Response to Questions

Figure 1: Continuity
 G-1, Continuity

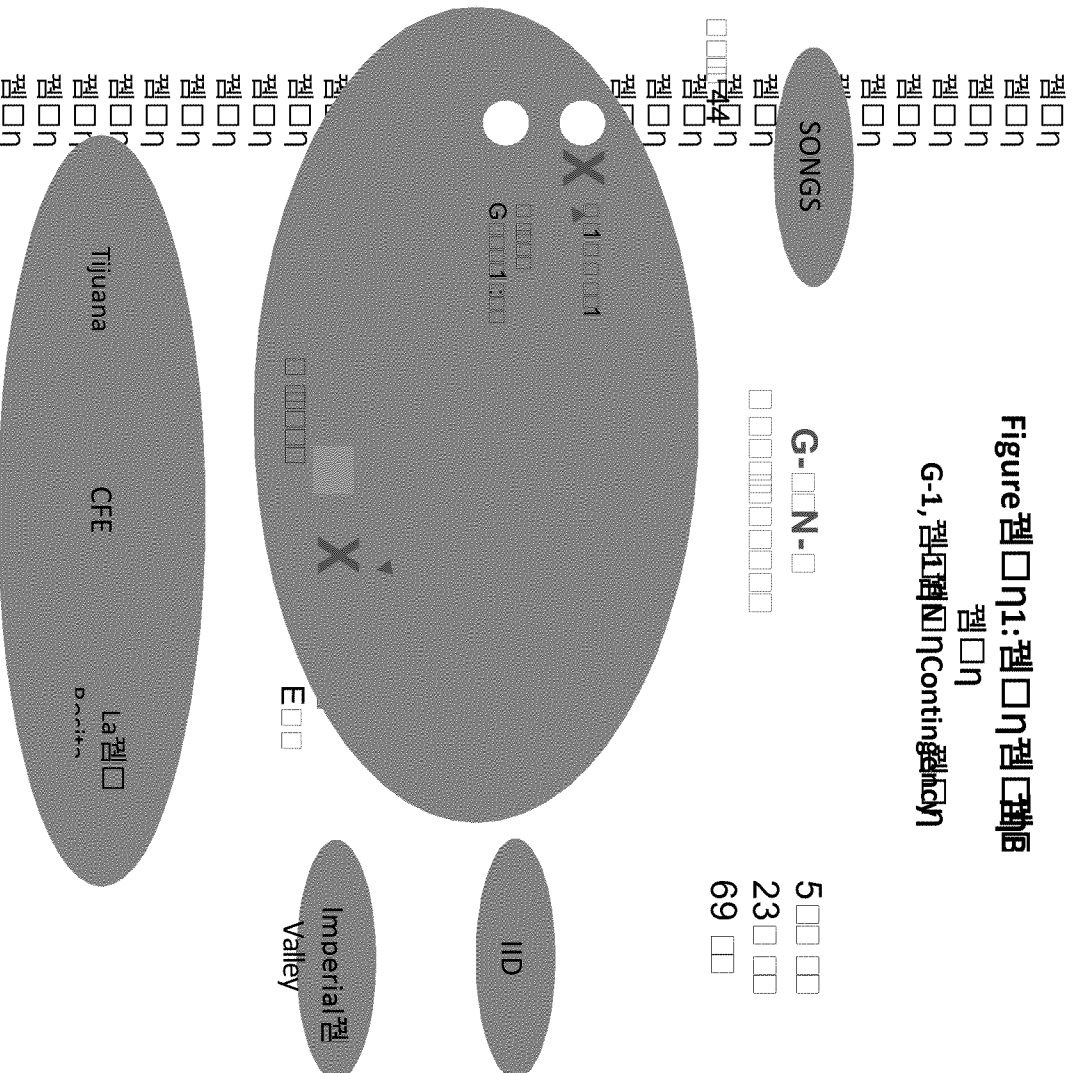
Q2: How can we explain the local capacity benefit provided by the Sun contingency? Why is this criteria used for the Sun project?

Before the construction of the Sunrise:
With everything else, the Sunrise project had not Category B contingency that the 1 of the 1,100 500 kv The West

Under these circumstances, the import level into the San could be subtracted from the peak load to determine the net available capacity. The net available capacity for the outage of this unit is approximately 500 MW. The results, from the analysis, are shown in the table below.
